Access Compliance Report

Public Rights-of-Way

Intersection ID: 2710	Main Street: FAIRVISTA_DR	Cross Street: QUEENSBURY_CT	Location: SW
ADA ID: E8B6FFBE683F	Ramp Type: PerpDiag	Initial Pass/Fail: Fail	Overall Compliance: No
			Severity Score: 33.75

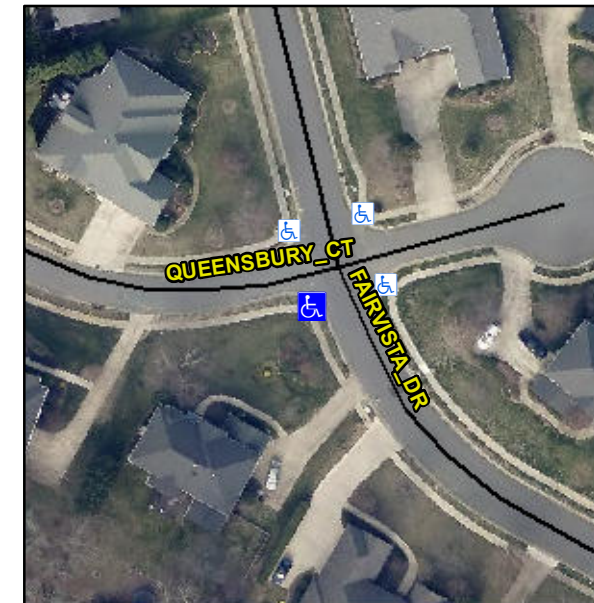
Not Found, R304.5.1, R304.2.2, R304.5.3

Compliance	Description	Data	Compliance	Description	Data
N/A	Ramp Length (in)	51.0	No	Ramp Slope (%)	10.8
No	Ramp Width (in)	41.0	No	Ramp XSlope (%)	5.4
N/A	Flare Type LT	N/A	N/A	Flare Type RT	N/A
N/A	Flare Slope LT (%)	N/A	N/A	Flare Slope RT (%)	N/A
N/A	Flare Traversable LT?	N/A	N/A	Flare Traversable RT?	N/A
N/A	Landing Length (in)	N/A	N/A	DWS Provided?	N/A
N/A	Landing Width (in)	N/A	N/A	DWS Contrast?	N/A
N/A	Landing Slope (%)	N/A	N/A	DWS Length (in)	N/A
N/A	Landing X Slope (%)	N/A	N/A	DWS Full Width?	N/A
N/A	Landing Curb? (Y/N)	N/A	N/A	DWS Offset (in)	N/A
N/A	Shared Landing?	N/A			
N/A	Gutter Ponding?	N/A	N/A	Gutter Slope (%)	N/A
N/A	Gutter Lip Ht (in)	N/A	N/A	Gutter X Slope (%)	N/A
N/A	Painted X Walk1?	No	N/A	Painted X Walk2?	No
	X Walk 1 Direction	To E		X Walk 2 Direction	To N
N/A	X Walk 1 Width (in)	N/A	N/A	X Walk 2 Width (in)	N/A
	X Walk 1 Slope (%)	5.2		X Walk 2 Slope (%)	3.5
	X Walk 1 X Slope (%)	3.0		X Walk 2 X Slope (%)	3.7

Remove & Replace Curb Ramp With Two New Directional Ramps or Equivalent.
